UNITED STATES PATENT AND TRADEMARK OFFICE

APPLICATION NO.	FILING DATE	FIRST NAMED INVENTOR	ATTORNEY DOCKET NO.	CONFIRMATION NO.
10/708,381	02/27/2004	Xiangdong Chen	FIS920030367US1	2380

Office Action Summary	Application No.	Applicant(s)	
	10/708,381	CHEN ET AL.	
	Examiner	Art Unit	
	Alexander Sofocleous	2824

DETAILED ACTION

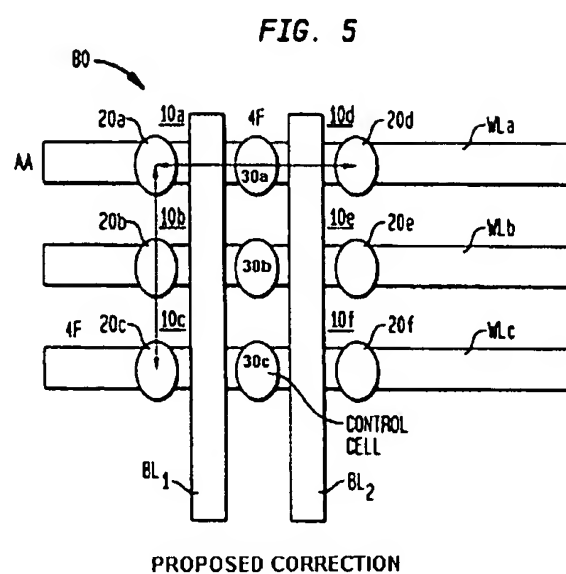
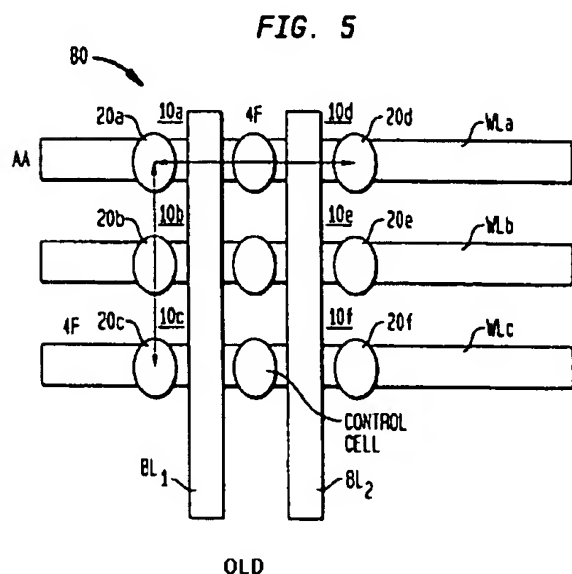
5. The drawings are objected to as failing to comply with 37 CFR 1.84(p)(5) because they do not include the following reference sign(s) mentioned in the

description: 30a, 30b, and 30c (see Fig. 5 with respect to paragraph 0025).

Examiner suggests adding 30a, 30b, and 30c to Figure 5 (see proposed correction below).
